CITY OF ALBUQUERQUE

Re: TMobile Retail Building
2706 Carlisle Blvd NE
Traffic Circulation Layout
Engineer's date 09-15-16 (H16-D148)

Based upon the information provided in your submittal received 09-15-16, the above referenced plan cannot be approved for Building Permit until the following comments are addressed:

DATE: 9/2/2016	sheet- C1.1
SCALE: AS NOTED	of 3

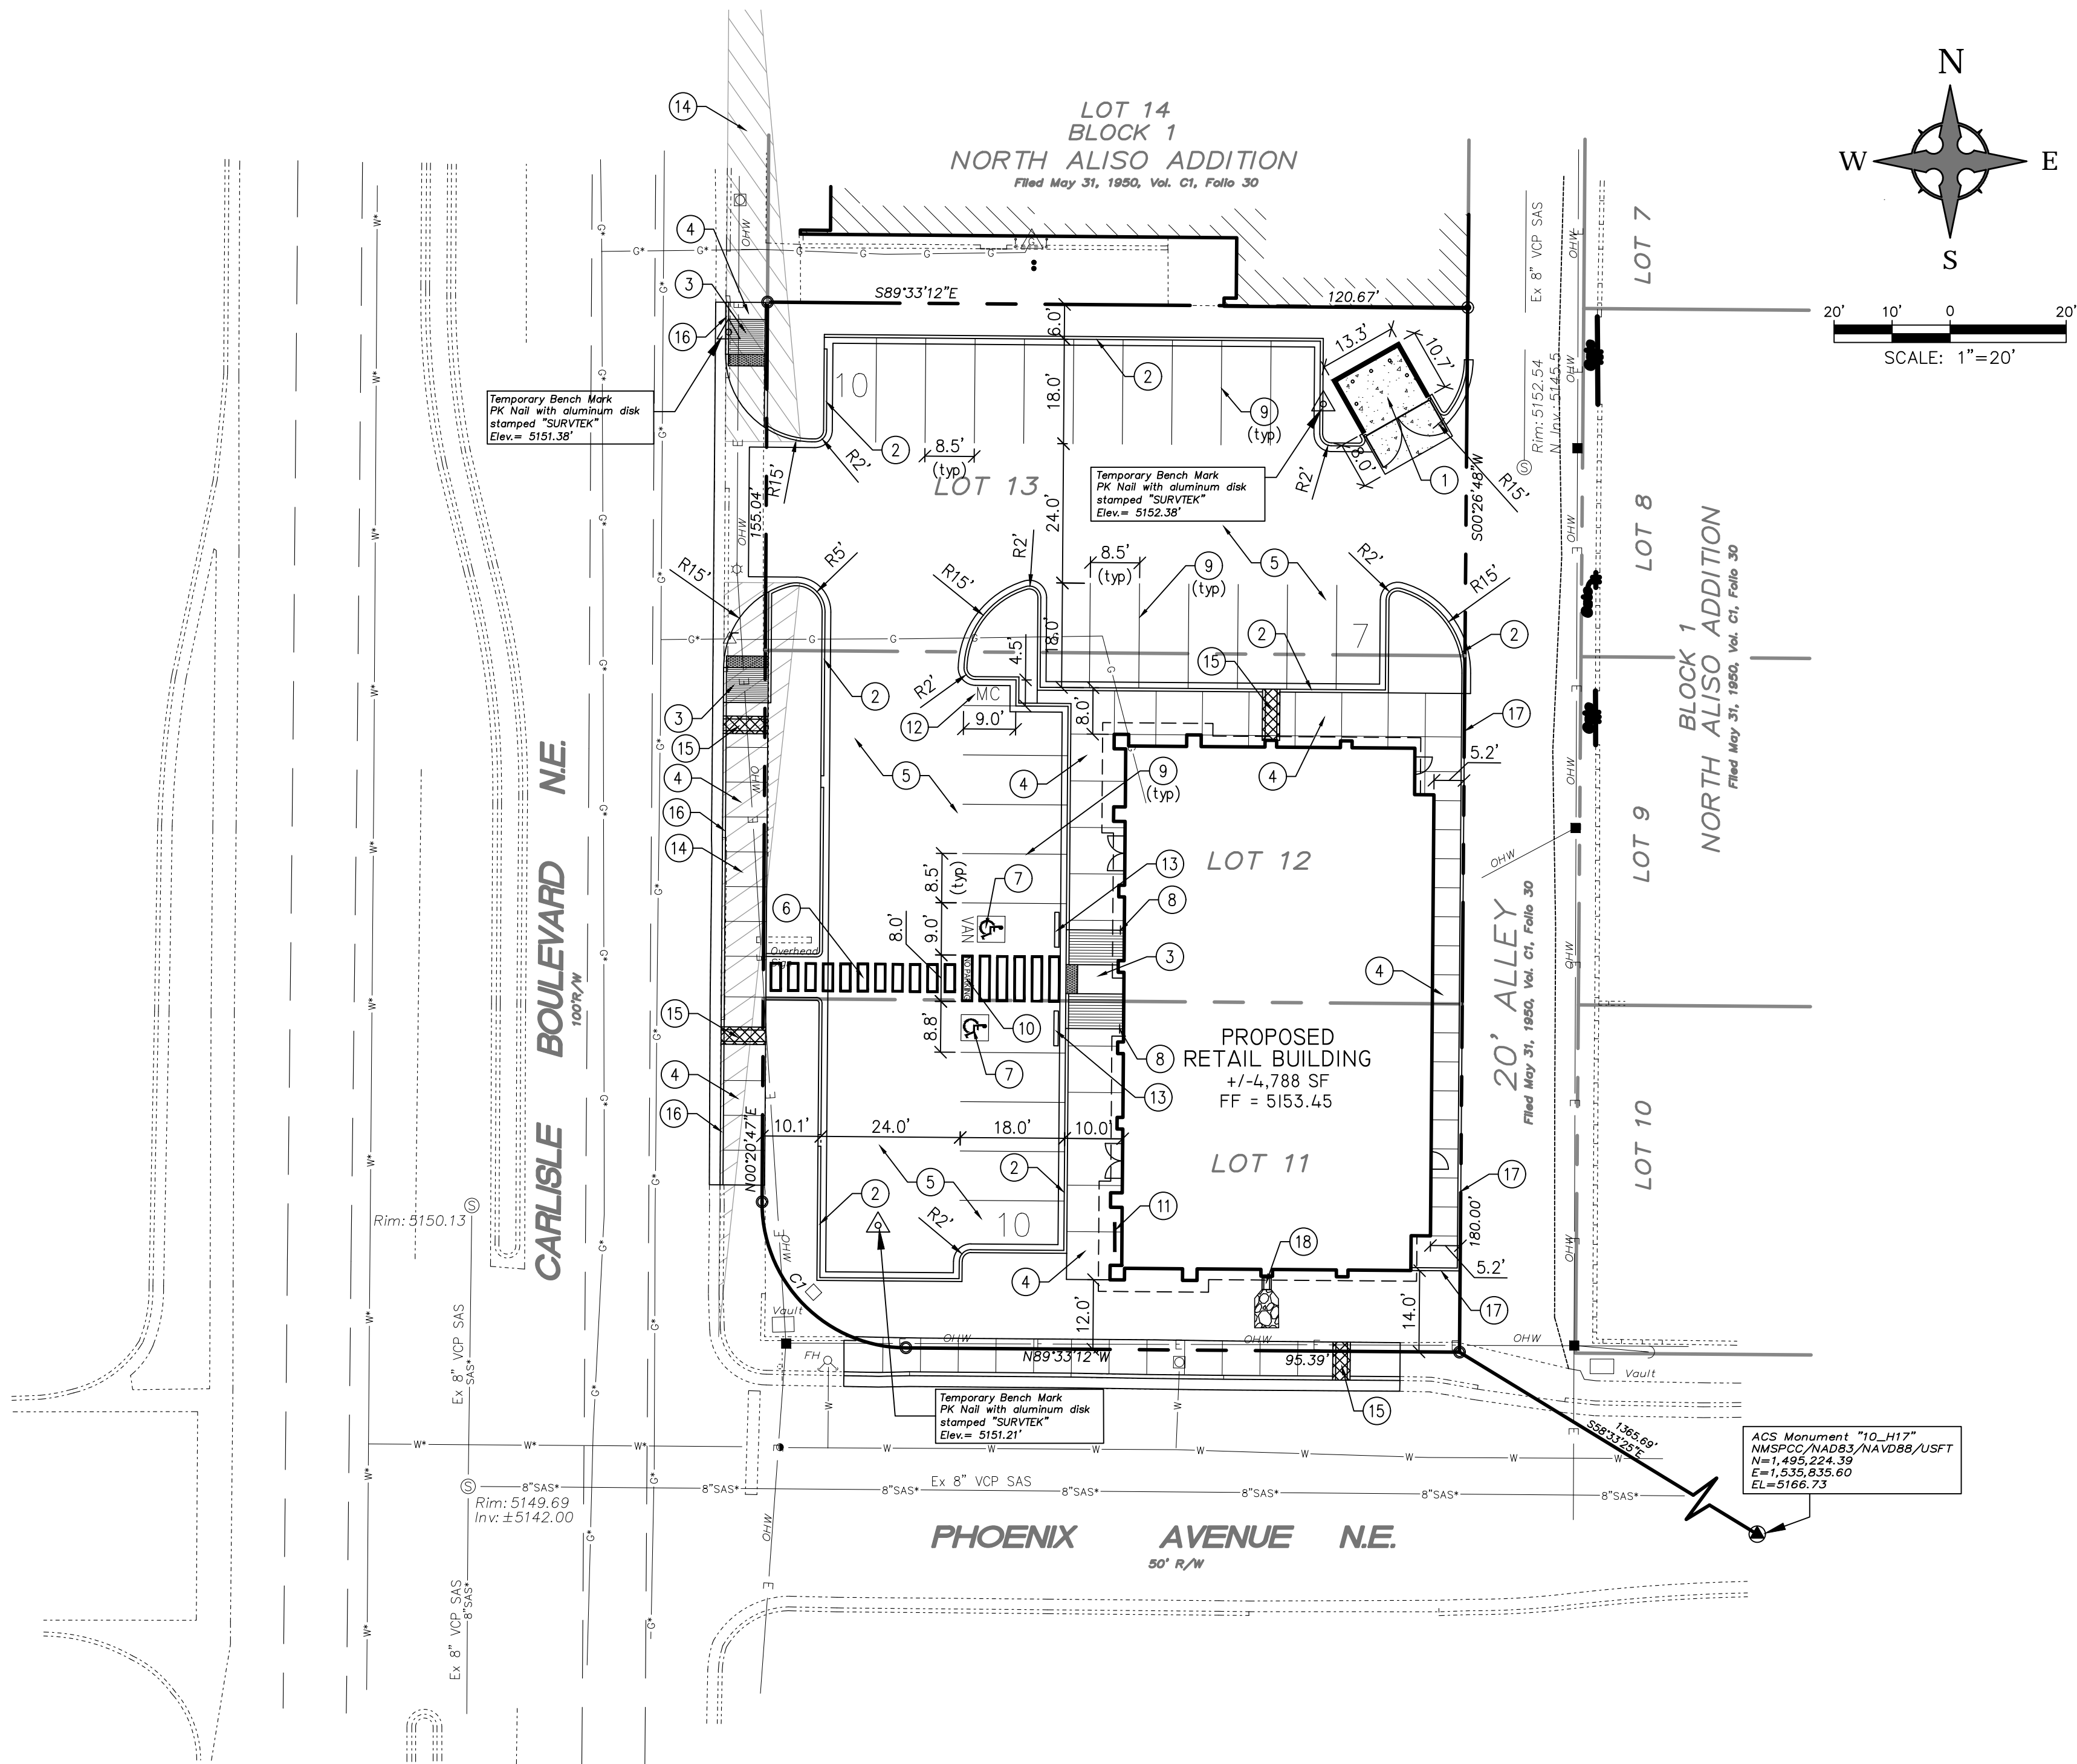
1. Please identify all existing drive pads and anything that influences the parking and circulation on the site. In particular the two drive pads on Phoenix and the light pole on Carlisle.

2. All sidewalks along streets should be placed at the property line. The sidewalk along Phoenix will require a sidewalk easement if it crosses the property line.

3. Please provide dimensions for the ADA wheelchair ramp on the corner of Phoenix and Carlisle and location of the power pole and fire hydrant at ramp. The ramp will require installation of a cast in place Detectable Warning Surface and will need to be replaced if it does not conform to ADA standards.

4. Please dimension on all ADA pathways. Connection from the sidewalk to the front should be 6 feet wide. Also use NMDOT ADA specifications 608-001 for Detectable Warning Surface detail and location, found at [http://dot.state.nm.us/content/dam/nmdot/Plans_Specs_Estimates/Standard Drawings/608.pdf](http://dot.state.nm.us/content/dam/nmdot/Plans_Specs_Estimates/Standard_Drawings/608.pdf). Add note for DWS "Cast in place replaceable".

5. Sidewalk culvert will require a SO19 permit.
